This errata sheet provides updated information about known device issues affecting Stratix® IV GX devices.

## Production Device Issues for Stratix IV GX Devices

**Figure 3. Instantiating and Connecting the `pll_locked_soft_logic` Module**

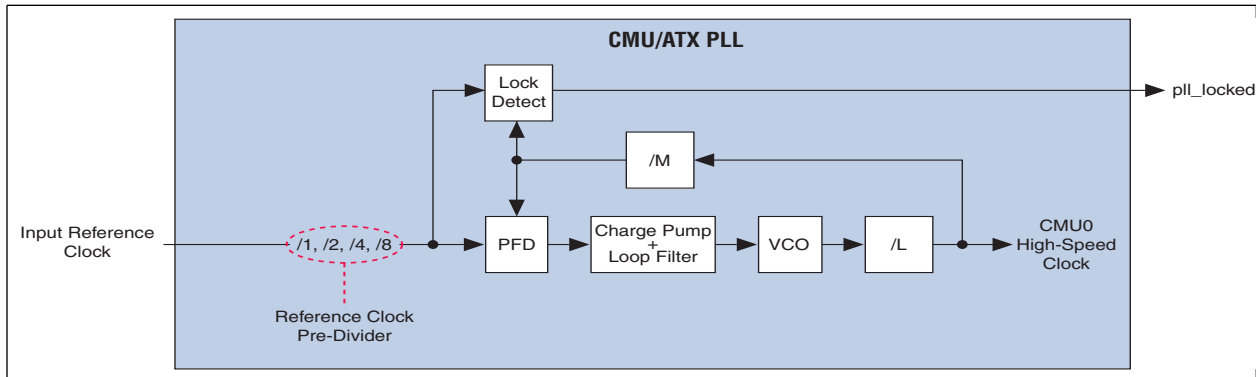
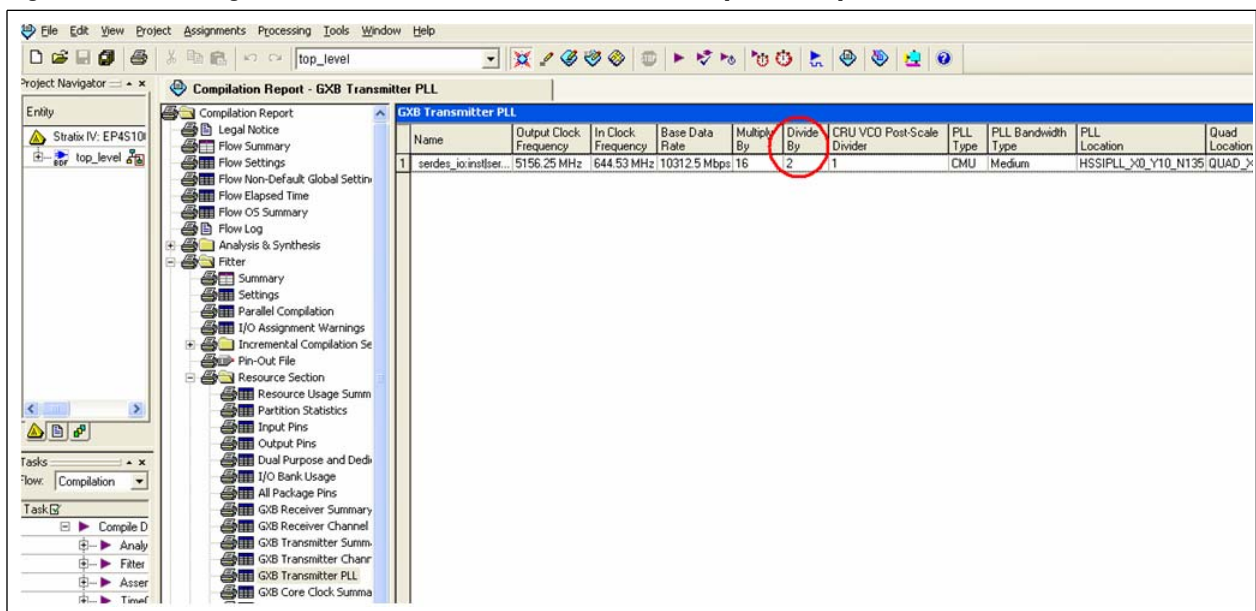
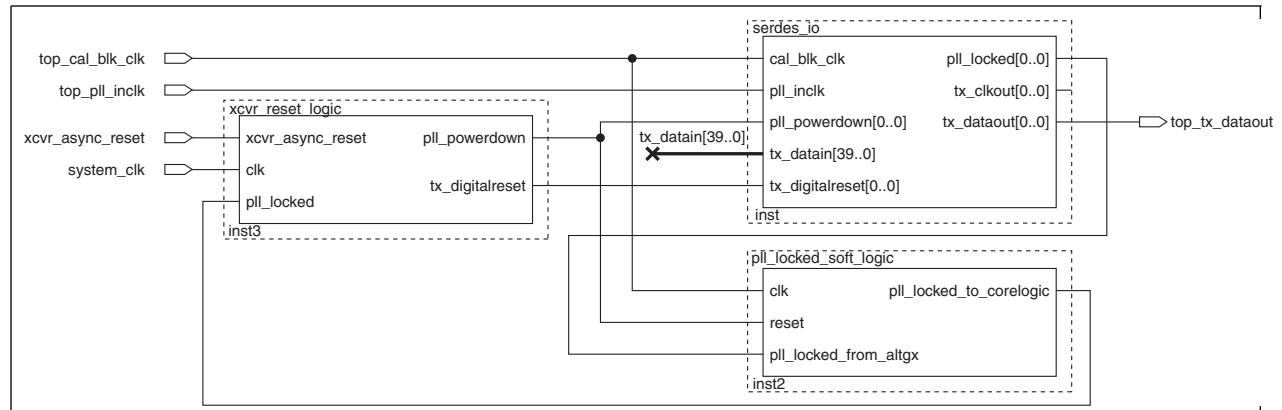
The transmitter PLL lock status signal (pll\_locked) does not deassert when the pll\_powerdown signal is asserted in configurations that use the reference clock pre-divider of 2, 4, or 8. Figure 1 shows the reference clock pre-divider inside transmitter PLLs. This transmitter PLL lock status signal issue impacts the pll\_locked status signal in both the CMU PLL and the ATX PLL.

Designs that implement the recommended transceiver reset sequence described in the *Reset Control and Power Down* chapter in volume 2 of the *Stratix IV Device Handbook* could potentially see a link failure after coming out of reset.

You can determine whether the Transmitter PLL in your design uses a reference clock pre-divider of 2, 4, or 8 by referring to the Quartus II software Compilation Report. Figure 2 shows an example of the GXB Transmitter PLL report, which you find in the “Resources Section” under “Fitter” in the Compilation Report. If the value in the **Divide By** column reads 2, 4 or 8, your design is impacted by the pll\_locked status signal issue.

If the `pll_locked` issue impacts your design, instantiate and connect the `pll_locked_soft_logic` module, as shown in Figure 3. Use the `pll_locked_to_corelogic` output from this module in the transceiver reset logic and any user logic that relies on the transmitter PLL lock status signal.

Click `pll_locked_soft_logic` to obtain the module.

Use the calibration block clock (`cal_blk_clk`) for the `pll_locked_soft_logic` module. The `cal_blk_clk` frequency specification ranges from 10 MHz to 125 MHz. Depending on your `cal_blk_clk` frequency, set the parameter `p_delay_counter` in the `pll_locked_soft_logic` so that the delay is equal to 100  $\mu$ s (worst-case transmitter PLL lock time).

**Figure 4. Placement Restrictions in Basic x8 Mode using ATX PLLs (6G)**

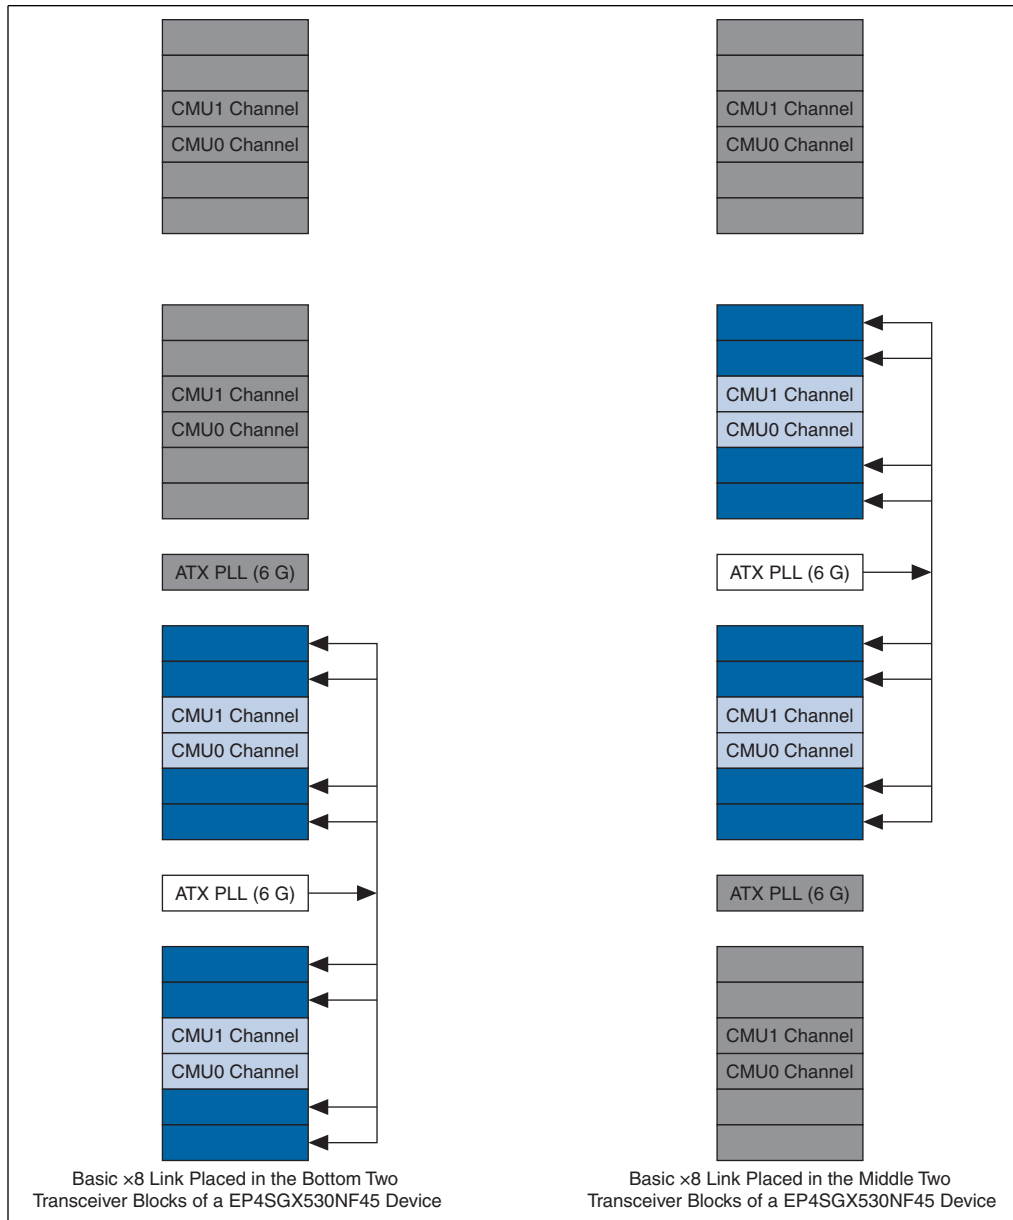
## x8 and xN Clock Line Timing Issue for Transceivers

The xN clock line timing issue in Stratix IV GX production devices affects the maximum data rate supported in the following transceiver configurations:

- Basic x8 functional mode using CMU PLL or ATX PLL (6G)
- Basic x1 and Basic x4 functional mode using ATX PLL (6G)
- Basic (PMA Direct) xN functional mode using CMU PLL or ATX PLL (6G)
- (OIF) CEI PHY Interface functional mode using ATX PLL (6G)

ALTGX Functional Mode	TX PLL Type	Bonding	Supported Data Rates			Placement Restrictions
			Speed Grade	$V_{CCL\_GXB}/V_{CCT}/V_{CCR}$ Supply Level (V) <sup>(1)</sup>	Max Data Rate (Gbps)	
Basic x8	CMU PLL	Up to x8	All	1.1	5.0	—
			C2/C3/I3	1.2 ± 0.05	6.5	
Basic x8	ATX PLL (6G)	Up to x8	All <sup>(2)</sup>	1.1	6.5	You must use the ATX PLL (6G) between the two transceiver blocks. For more information, refer to <a href="#">Figure 4</a> .
Basic x1 and Basic x4	ATX PLL (6G)	Up to x4	All <sup>(2)</sup>	1.1	6.5	You must use the ATX PLL (6G) adjacent to the transceiver block where the channels are located. For more information, refer to <a href="#">Figure 5</a> .
Basic (PMA Direct) xN	CMU PLL	Up to x17	All	1.1	5.0	Bonded channels must be contiguous. You must use the CMU PLL in the middle transceiver block. For more information, refer to <a href="#">Figure 6</a> .
			C2/C3/I3	1.2 ± 0.05	6.5	
		> x17	All	1.1	3.25	—

ATX PLL (6G)	Up to x12	All	1.1	6.5	Bonded channels must be located in two adjacent transceiver blocks. You must use the ATX PLL located between these two transceiver blocks.
> x12			All <sup>(2)</sup>	1.1	5.0	You must use ATX L1 PLL (6G) for left-side bonding. You must use ATX R1 PLL (6G) for right-side bonding. For more information, refer to <a href="#">Figure 7</a> .
> x12	C2/C3/I3	1.2 ± 0.05	6.5			
(OIF) CEI PHY Interface	ATX PLL (6G)	—	All <sup>(2)</sup>	1.1	6.375	You must use the 6G ATX PLL adjacent to the transceiver block where the channels are located.

**Figure 8. Recommended Flow When Compiling Designs Targeting Stratix IV GX Production Devices**

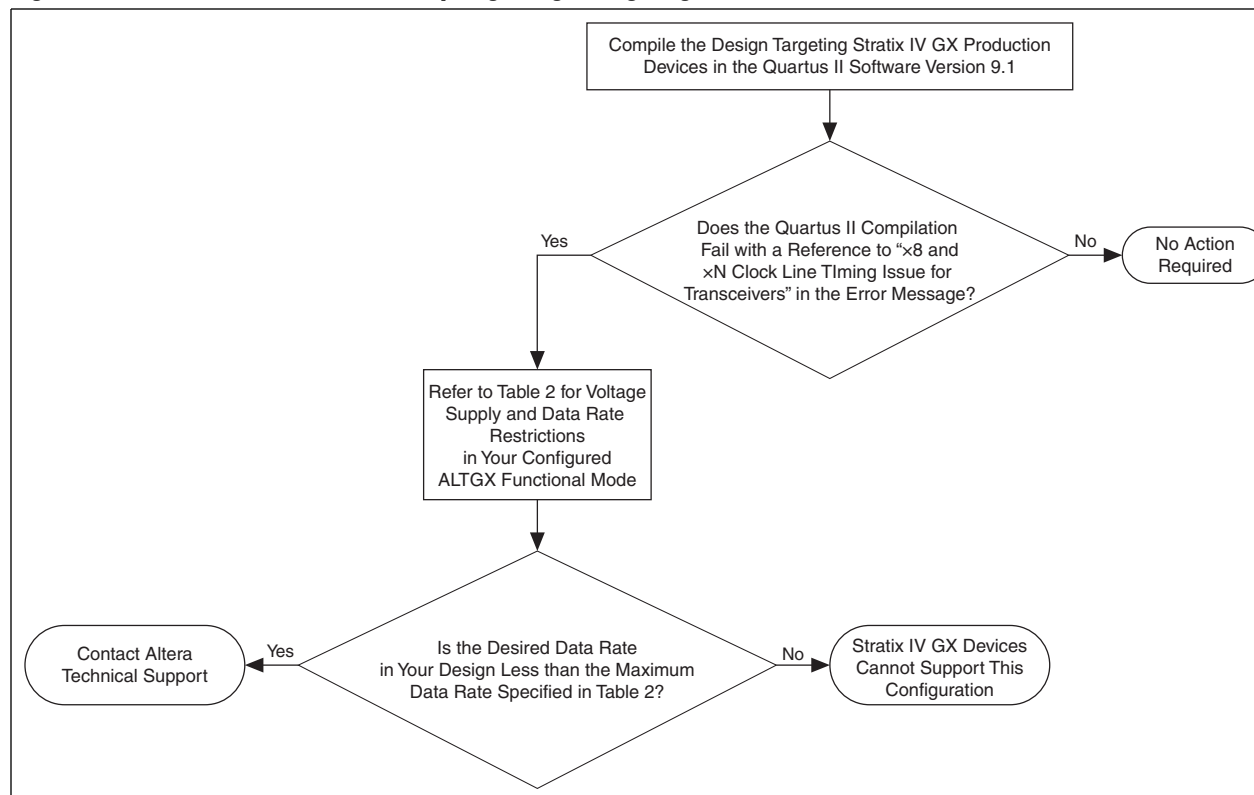
For Stratix IV GX production devices, the Quartus II software version 9.1 does not implement the correct data rate restrictions shown in [Table 2](#).

Follow the recommended flow in [Figure 8](#) when you compile designs with the Quartus II software version 9.1 that target Stratix IV GX devices.

**Figure 9. Setting Voltage Levels**

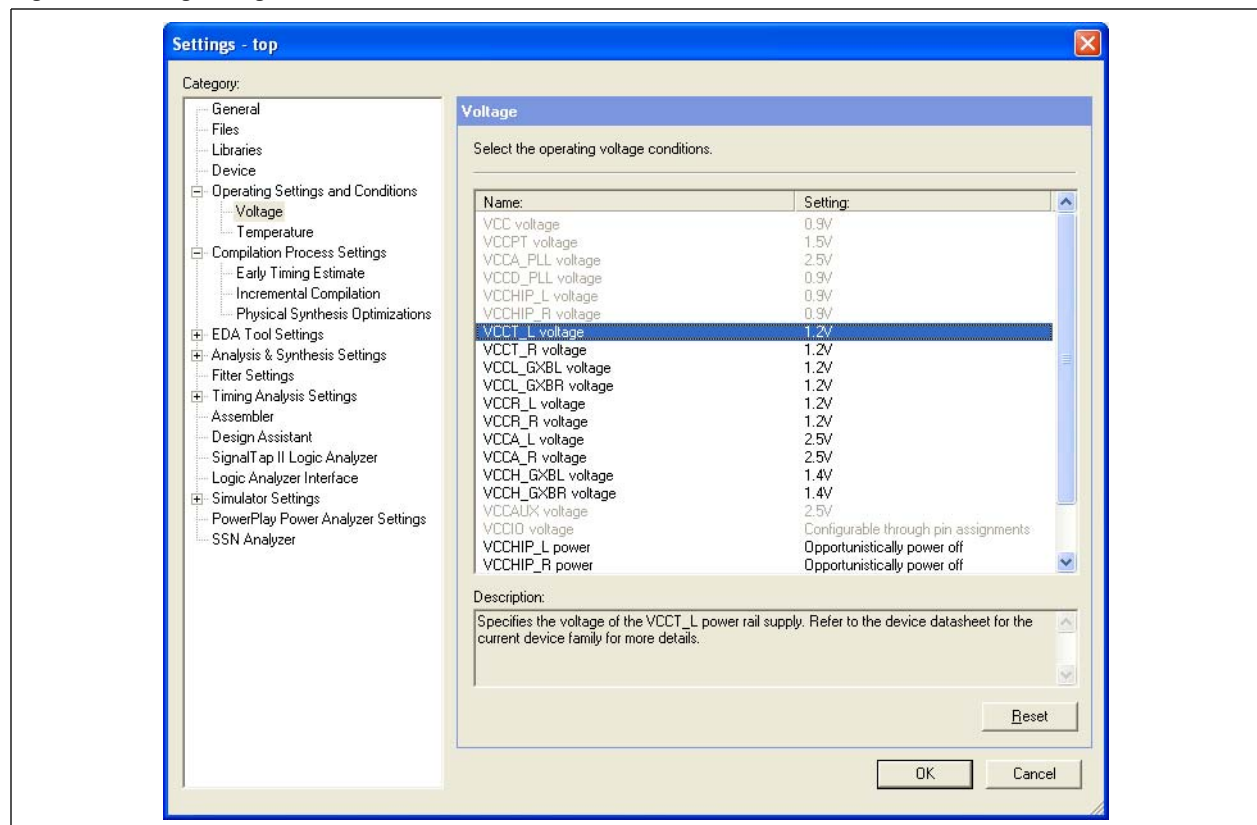
- **Category 2:** The configured xN line data rate is greater than the maximum data rate supported by 1.1 V, but less than or equal to that supported by the 1.2-V power supply level specified in [Table 2](#).

The Quartus II Compiler flags the following compilation error:

Action: In the Quartus II software, on the Assignments menu, click **Settings**. Click the "+" icon to expand **Operating Settings and Conditions** and select **Voltage**. Set the **VCCT\_L/R**, **VCCL\_GXBL/R**, and **VCCR\_L/R** voltage settings from **1.1V** to **1.2V**, as shown in [Figure 9](#). Then recompile the project.

**Figure 10. Rate Match FIFO Skew**

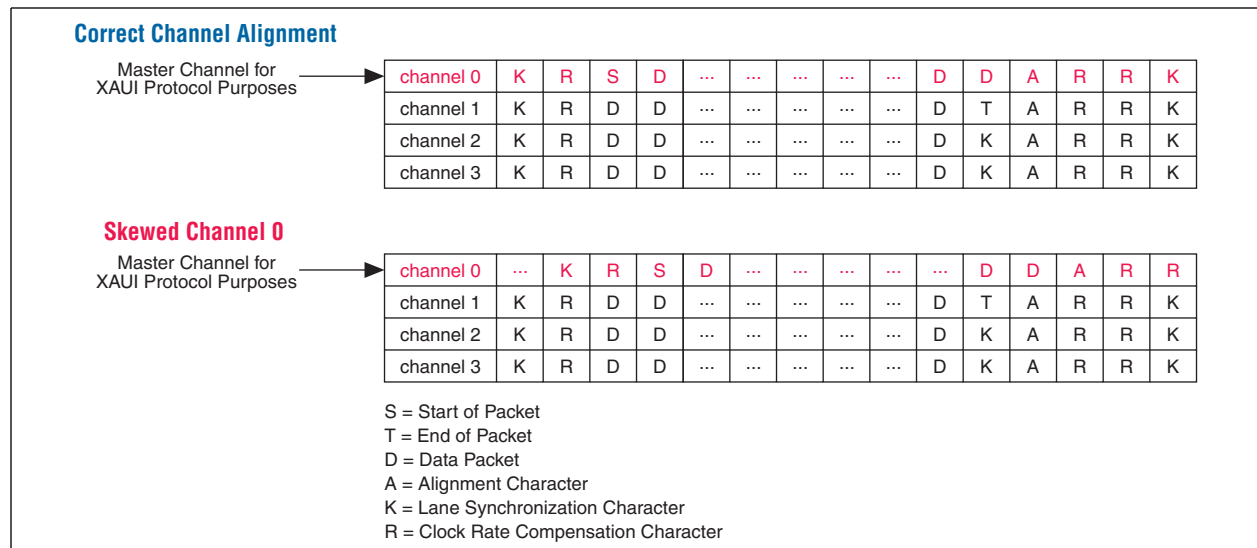
In XAUI functional mode, the data out of the physical transceiver channel 0's Rate Match FIFO may be shifted by one byte with respect to the data of the other three channels. This shift causes incorrect idle ordered set conversion, resulting in incorrect received parallel data. The corrupted received parallel data caused by improper idle ordered set conversion or rate matcher corruption happens only during initialization or receiver channel reset (assertion of rx\_analogreset or rx\_digitalreset).

Figure 10 shows the channel skew.

Altera provides a soft IP solution and associated documentation, available for download at: [www.altera.com/patches/xau-softip/xau-softip-fix-reva.zip](http://www.altera.com/patches/xau-softip/xau-softip-fix-reva.zip)

Integrate this soft IP into the XAUI receiver data path.
